## Draft DCP Amendments

Figure 3: Land in Revesby (shown blue) where new buildings must submit a safety management plan (subject to formatting)

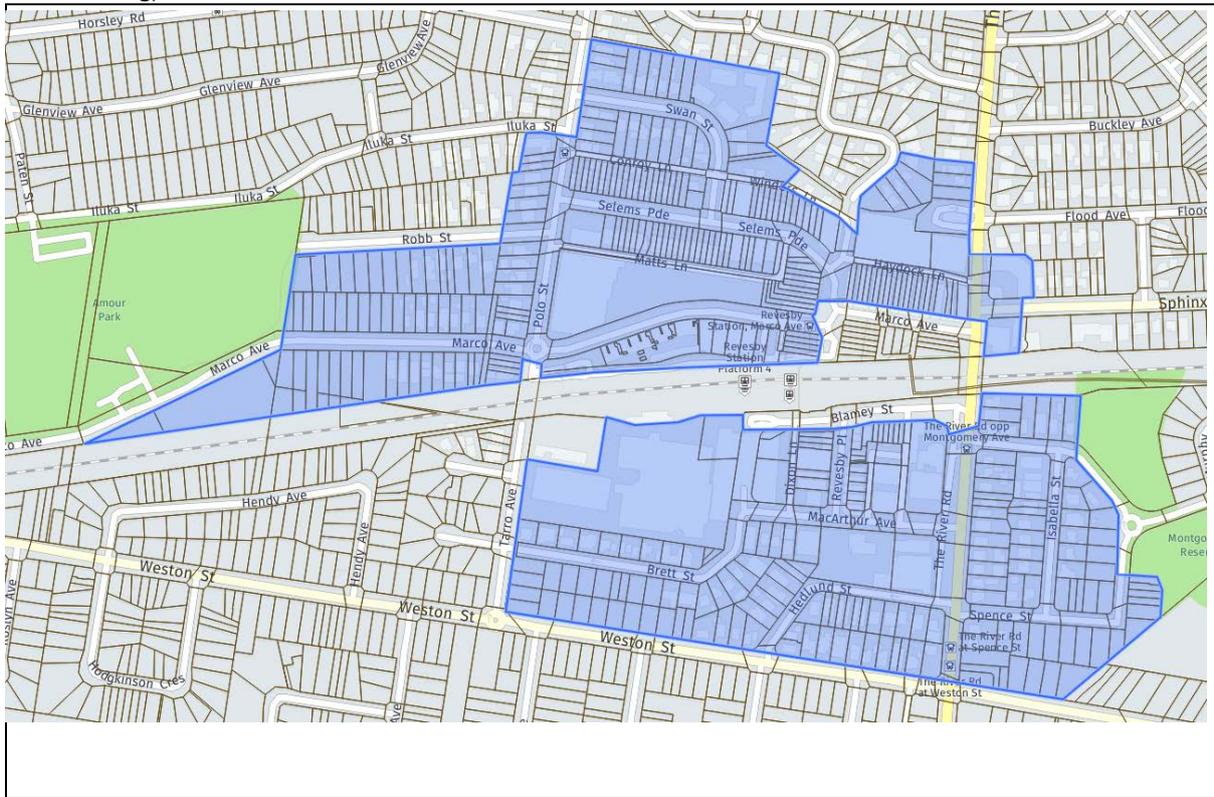
**1.4** *Council requires the erection of new buildings on land shown in Figures 1–4 to submit a safety management plan in accordance with the Australian Standard 2885 (Standard for Gas and Liquid Petroleum Pipelines) to assess the land use and construction risks.*
